Technical Information Bulletin

Subject: Feed Tray & Side to Side Registration **BULLETIN NO.: 137**

[ ] Factory Modification [ ] Field Modification [ ] Safety Information [X] Technical Information [ ] General Information [ ] Adv. Tech Information	Applies to: ALL GR - CE Units	Modification Schedule: [ ] TBS [ ] Next Call [ ] Next PM [X] As Necessary	Factory Installed_____ Field Installed_____ FittingTime _____

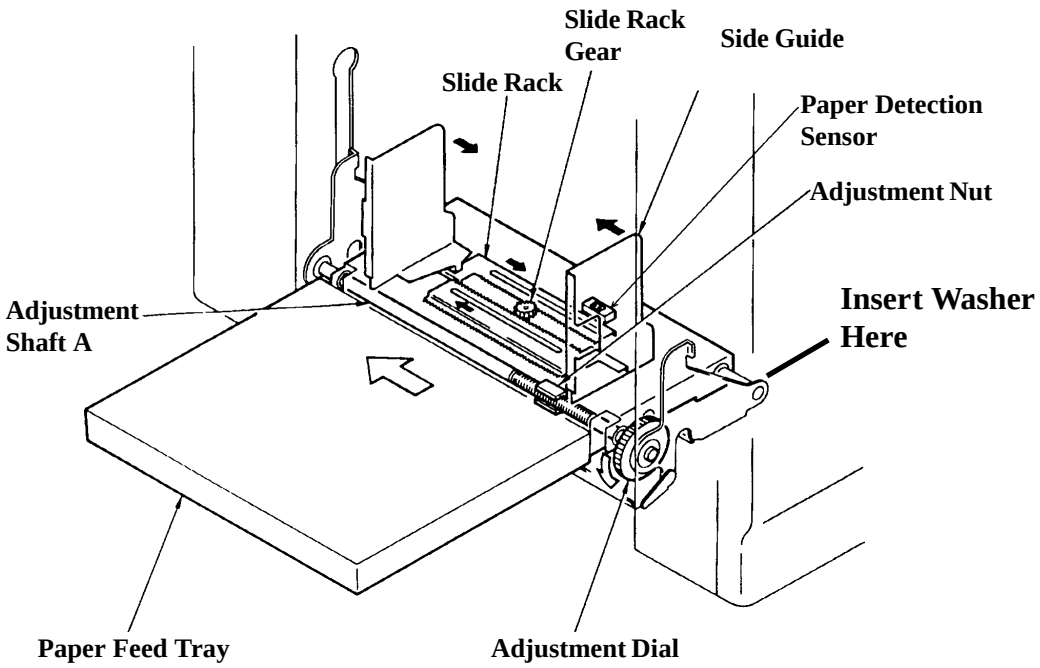
Some Paper Feed Trays have excess side to side movement.
Excess side to side movement may effect side to side registration. This is noticable on a second pass.

Insert a washer on the shaft between the C-clip and the paper feed tray.
The hole in the washer should be 10mm to 12mm, the outside diameter should be 14mm to 20mm and the washer thickness should be 1mm to 3mm.
